*City of Biddeford*

**Planning Board**

6.A. 2021.31 Final Review of a 6-Lot Cluster Subdivision for Ginger Hill Design + Build at 918 Pool Street (Tax Map 4, Lot 48) in the Coastal Residential (CR) and Rural Farm (RF) Zones.

PLANNING BOARD  
REPORT

# Subdivision Plan

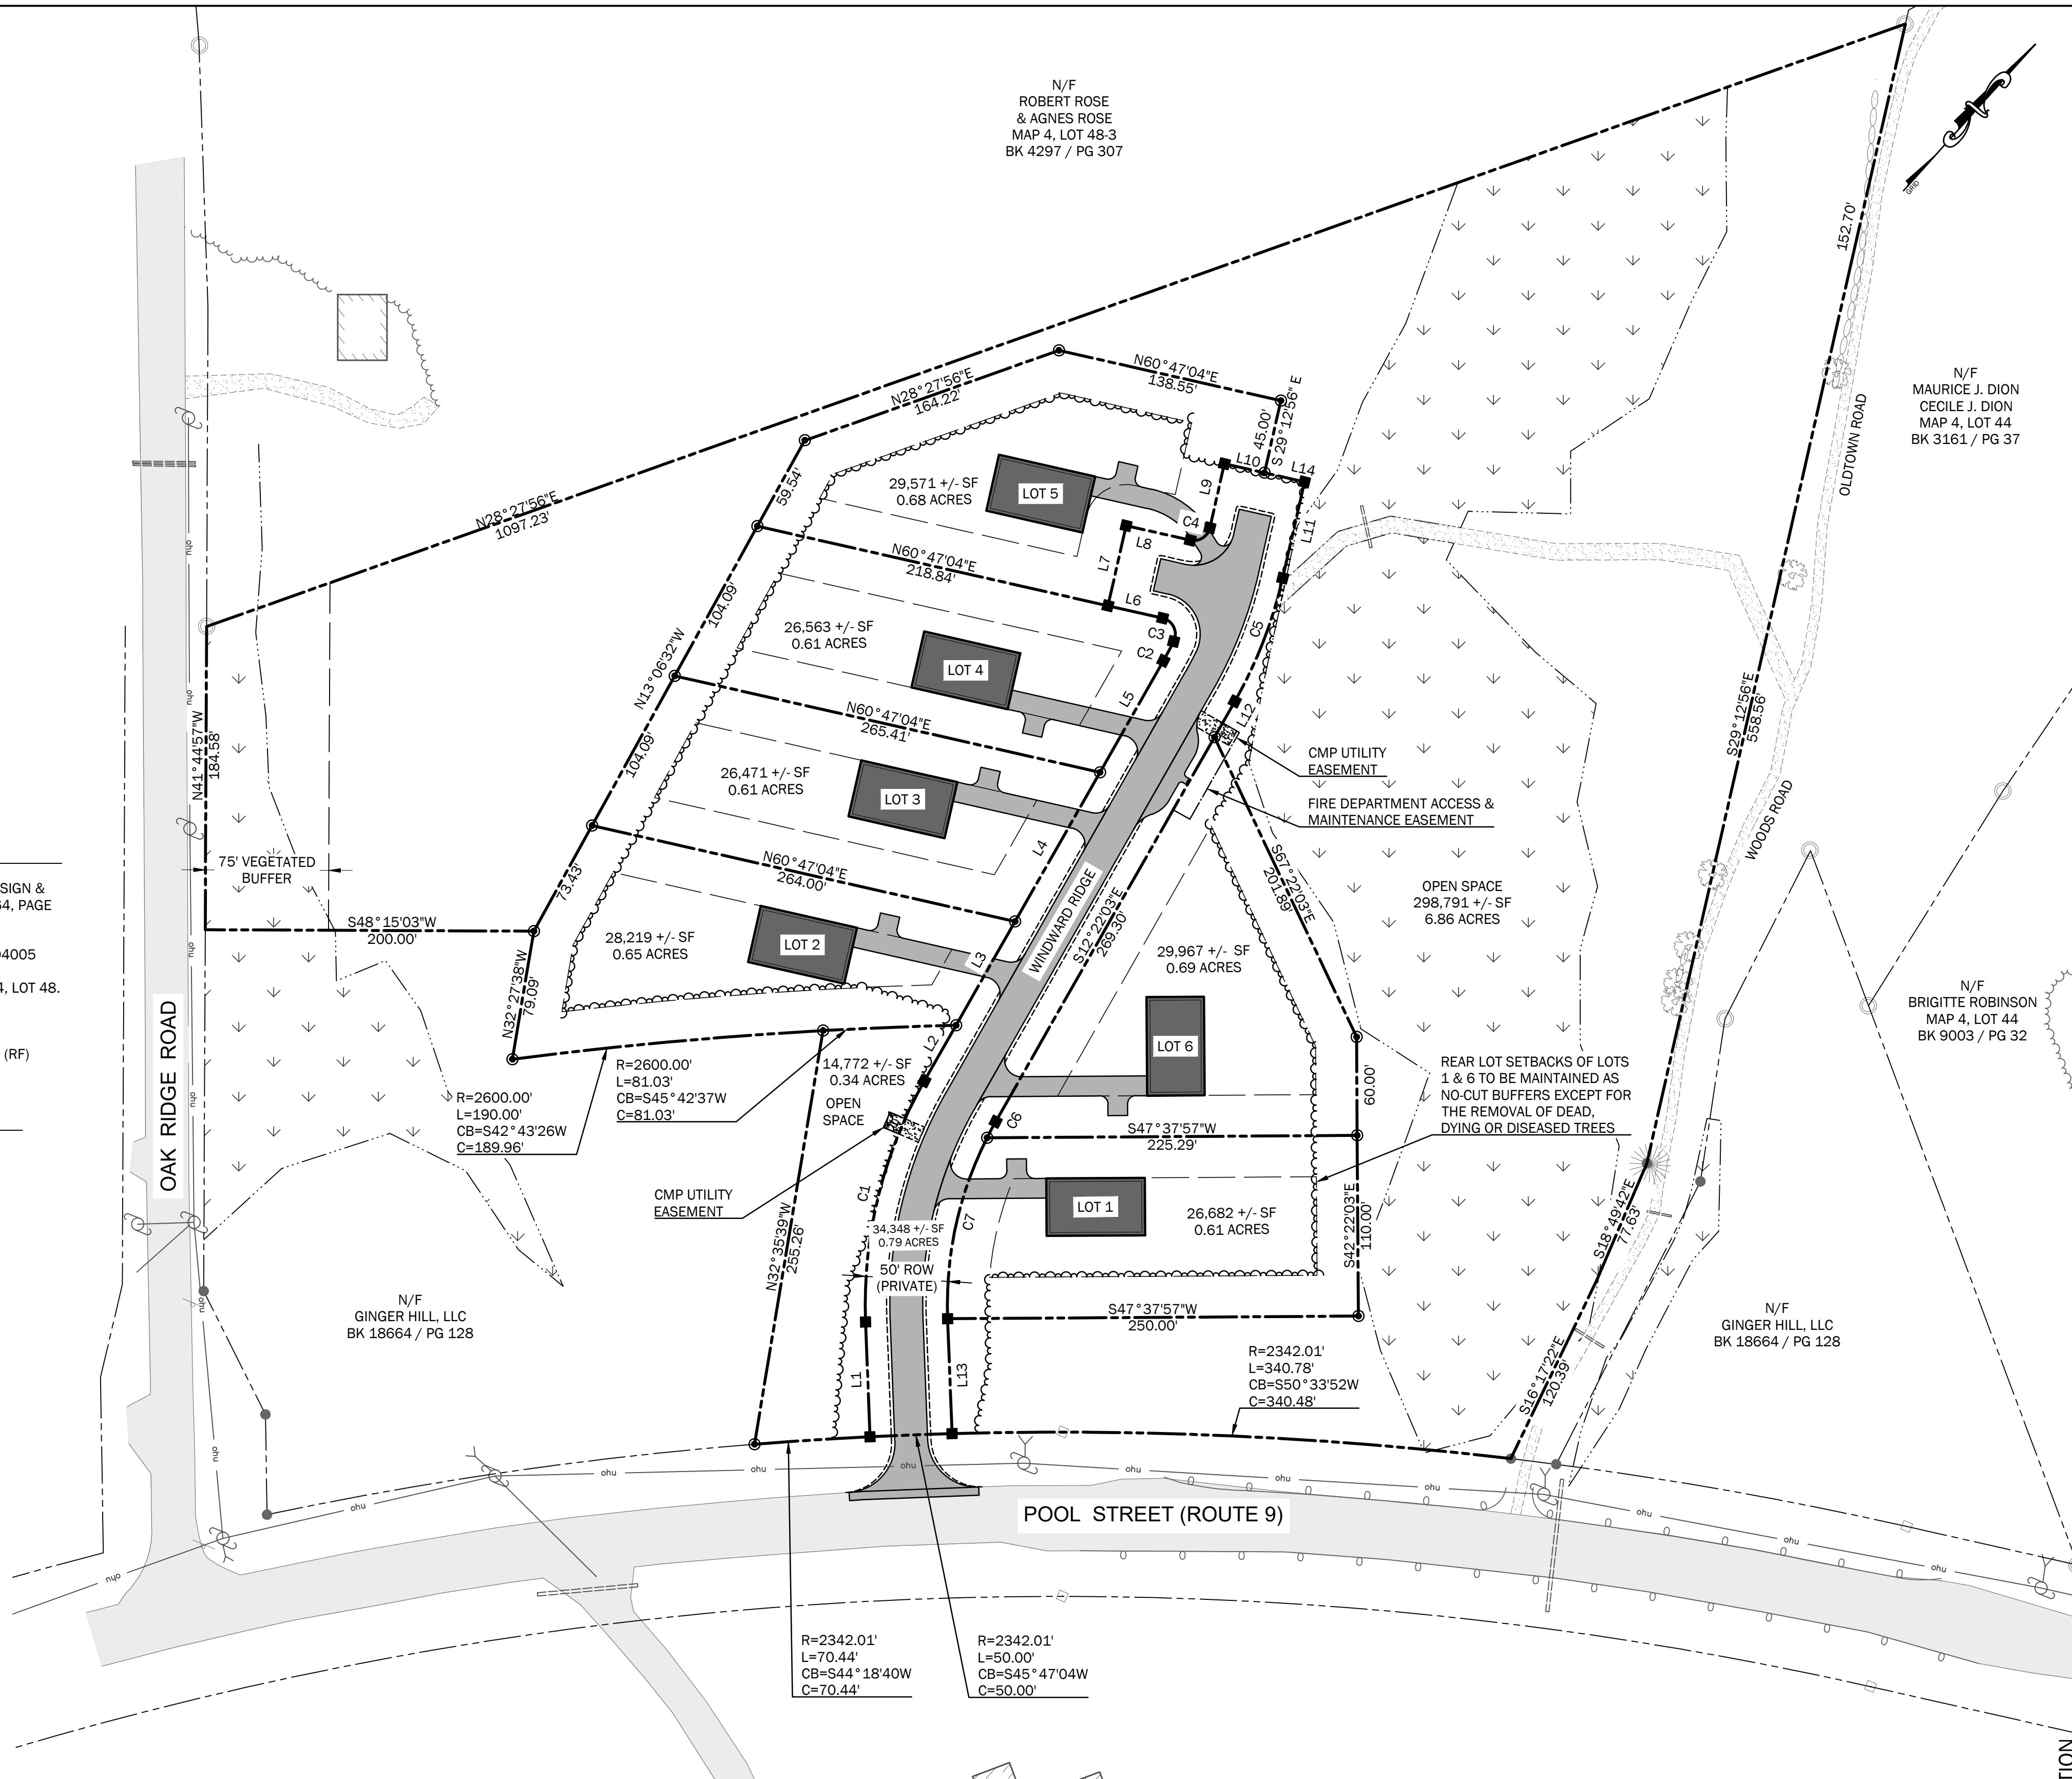
7. Plan note 4 on Sheet S1.0 should be more specific and reference the actual declaration of covenants and restrictions and the conservation easement. **The plan note has been revised. It is recommended that the note reflects the documents are recorded at the York Registry of Deeds.**

7. *Plan note 4 on Sheet S1.0 should be more specific and reference the actual declaration of covenants and restrictions and the conservation easement.*

**The applicant has addressed this comment with a note on Sheet S1.0 (Subdivision Plan) requiring rear setbacks for Lots 1 and 6 to be maintained as a *no-cut buffer*. Lot 5 has been modified to allow for a 15-foot wide strip of open space between the lot and the abutting property.**

Response: Note 4 has been revised on Sheet S1.0 to refer to the Conservation Easement.

Response: Buffering note at the wetland easterly of lots 1 & 6 has been revised to show no cutting in the building window setback. Refer to the subdivision plan, Sheet S1.0

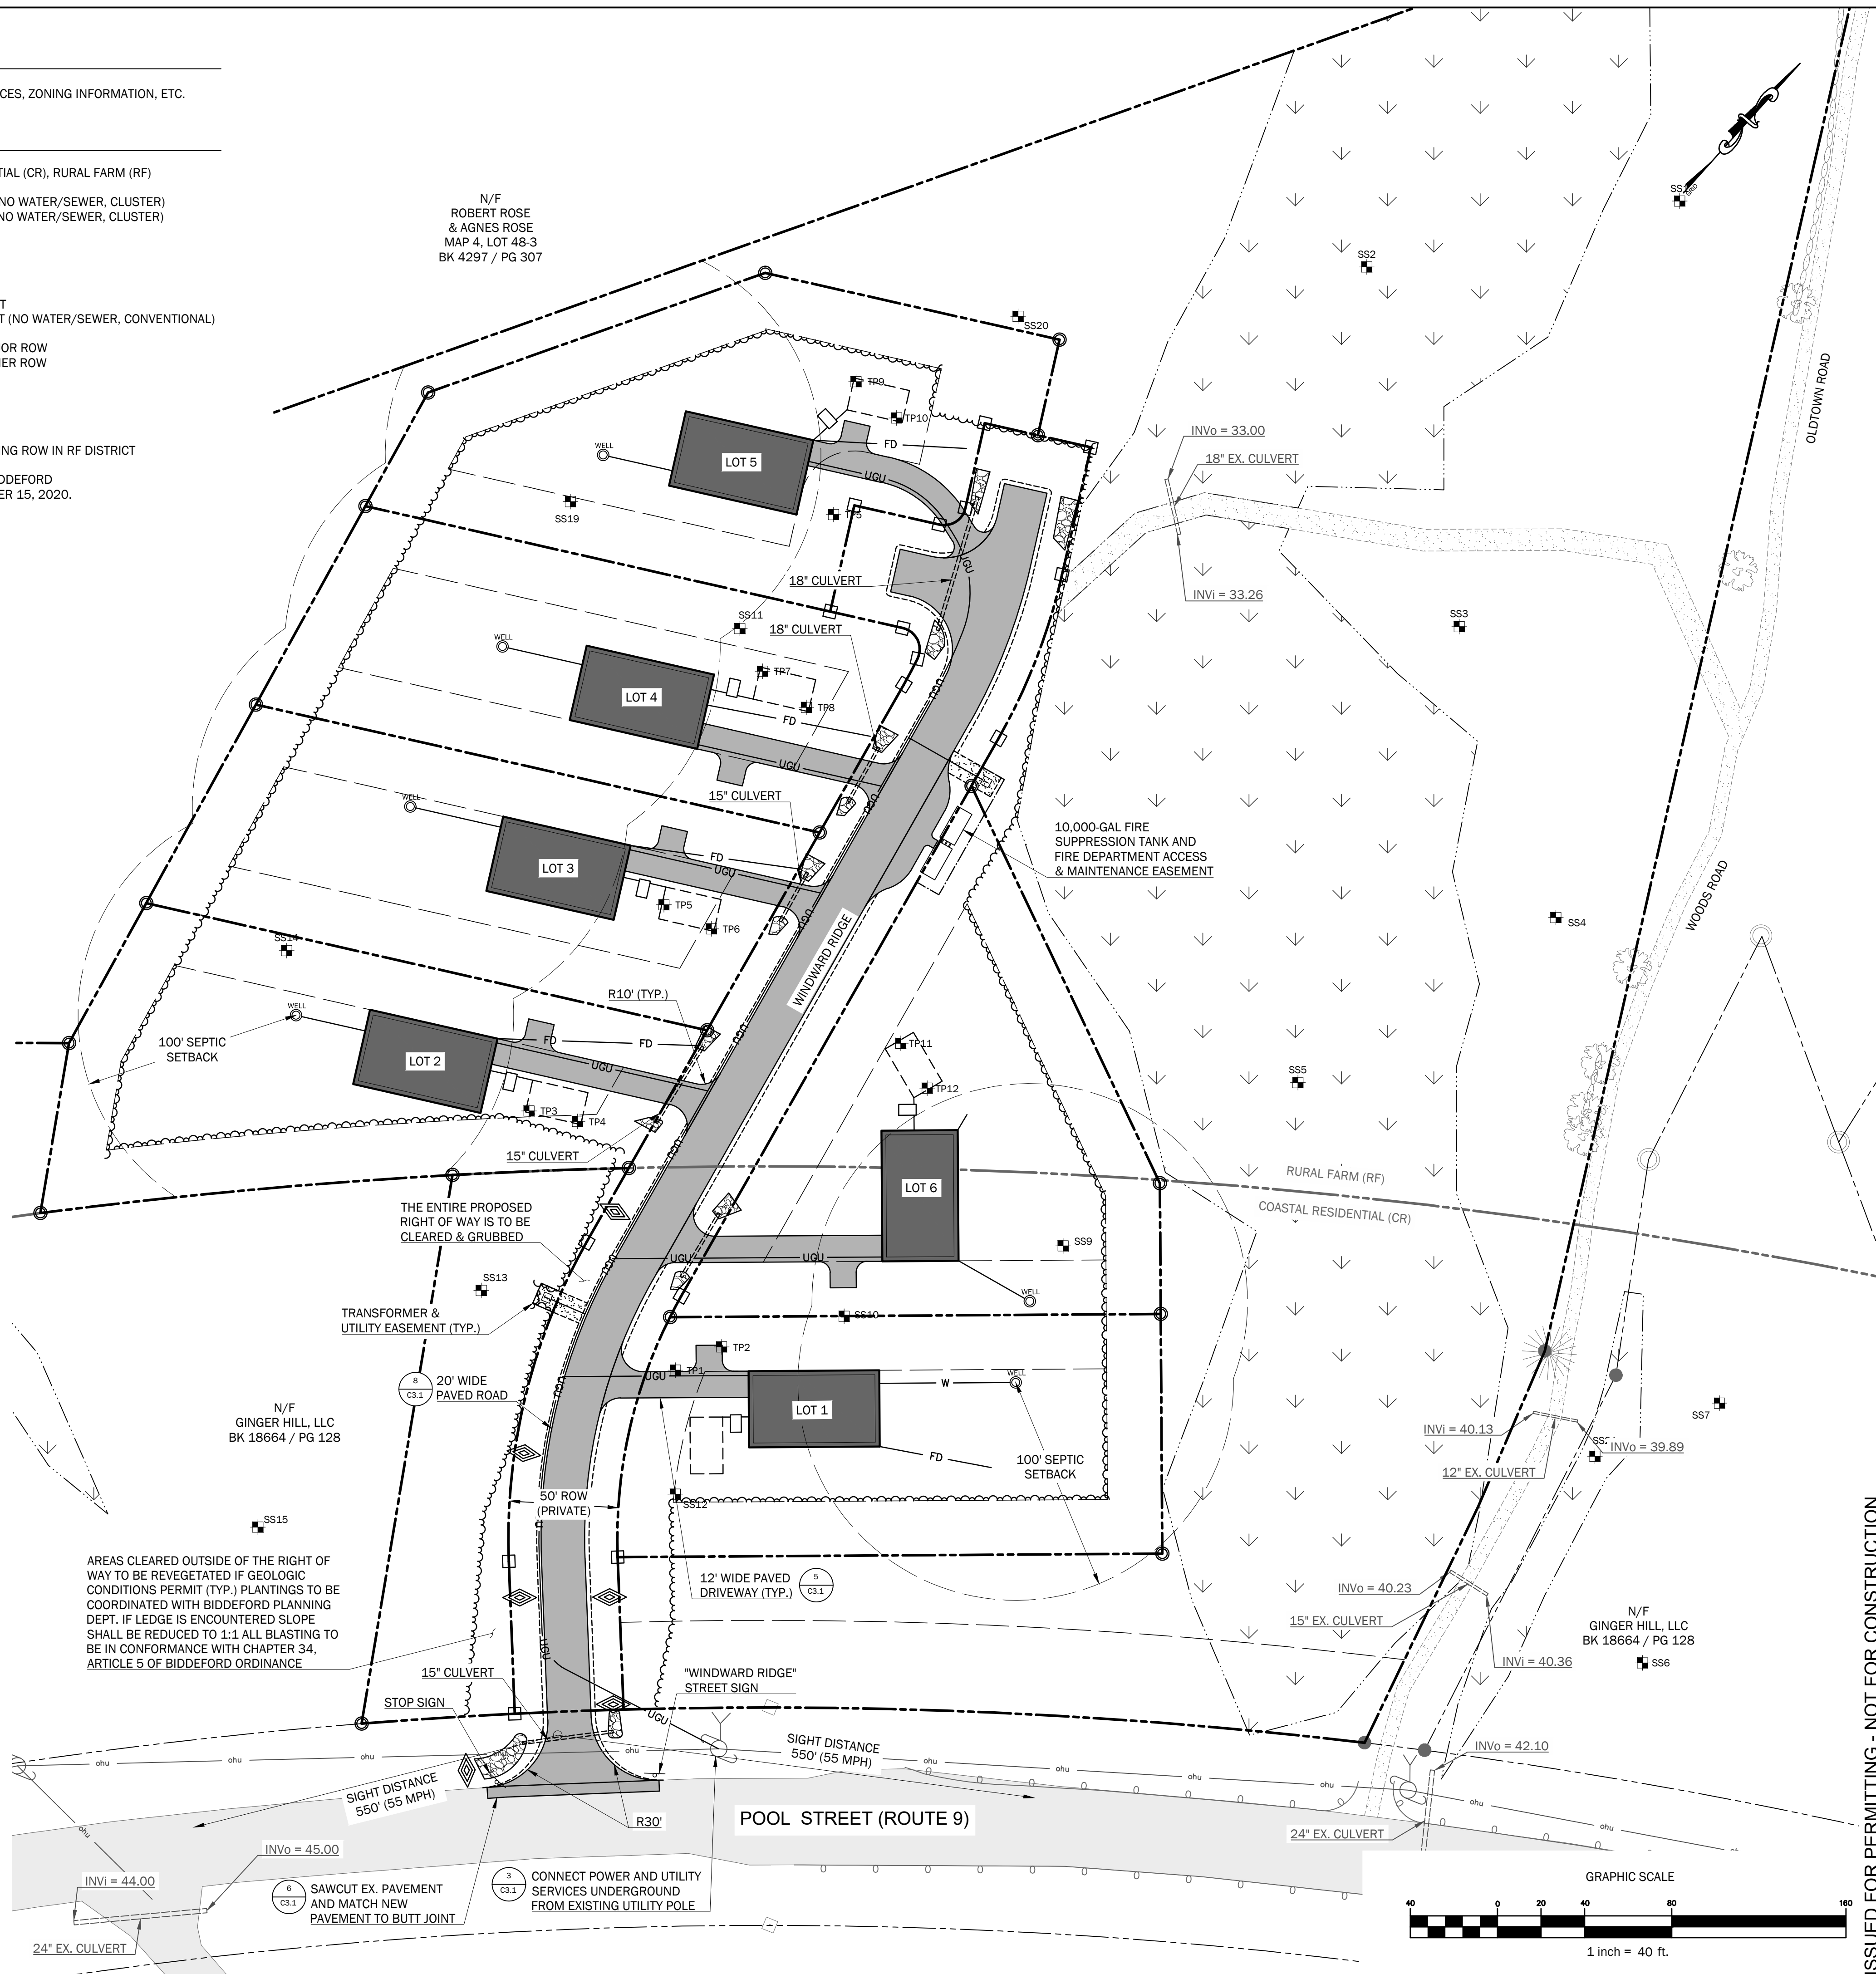
*Comment: The proposed roadway from Pool Street incurs a great deal of clearing and grading (Sheet C2.3) outside of its Right-Of-Way, that will result in a significant hole in what is now is dense woodland edge. Plantings of trees and shrubs should be considered to either side of the entrance within the lot and open space land that would provide an adequate screen and soften the associated clearing.*

Response: As discussed with the Board, it is very likely that the road will be cut through ledge. With that, it is possible to increase the side slopes to 1H:1V which would limit the removal of trees. We have added a note to Sheet C2.0 stating “Areas cleared outside of the Right of Way to be revegetated if geologic conditions permit. Plantings to be coordinated with Biddeford Planning Dept. If ledge is encountered slope shall be reduced to 1:1. All blasting to be in conformance with Chapter 34, Article 5 of Biddeford Ordinance”. We would respectfully request that it be a condition of approval that the applicant resolves this issue with staff after the actual conditions are determined.
